**Olympus reference: QIL FY25-EMEA-28-FY25-013 Guide Sheath Component****URGENT: FIELD SAFETY NOTICE****RE: Single Use Guide Sheath Kit****Attention:** Endoscopy Department, Bronchoscopy Suite, Pulmonology, Risk Management

Olympus is writing to inform you of a Field Corrective Action pertaining to the Single Use Guide Sheath Kits, models K-201, K-202, K-203, and K-204. These instruments have been designed to be used with an Olympus endoscope to collect cells or tissue specimens in the respiratory organs.

Figure 1: Single Use Guide Sheath (models SG-200C and SG-201C)

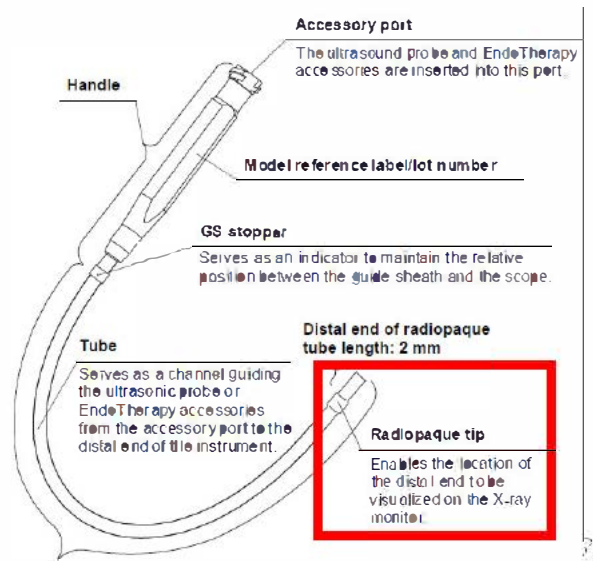
Olympus conducted an investigation into the Single Use Guide Sheath Kits after receiving complaints that the radiopaque tip of the guide sheath component (see Figure 1 below), fell off into the patient. Since July 2021, Olympus has received 32 complaints involving intraoperative disassociation of the guide sheath radiopaque tip in which the tip fell off into the patient. Of these 32 complaints, 26 were reported as serious injuries, and 6 were reported as malfunctions. The preliminary findings from Olympus' investigation have identified that the disassociation of the tip from the guide sheath is likely the result of excessive force applied when inserting instruments into the guide sheath, and/or damage to the distal end of the sheath.

Olympus has launched the next generation of the Single Use Guide Sheath Kits, models K-401, K-402, K-403, and K-404, which has a different radiopaque tip design. Therefore, Olympus has discontinued the previous generation models (K-201, K-202, K-203, and K-204) and is removing these models from the market.

You should stop using the K-201, K-202, K-203, and K-204 Single Use Guide Sheath Kits as soon as possible. The next generation Single Use Guide Sheath Kits, models K-401, K-402, K-403, and K-404, should be used by your facility instead.
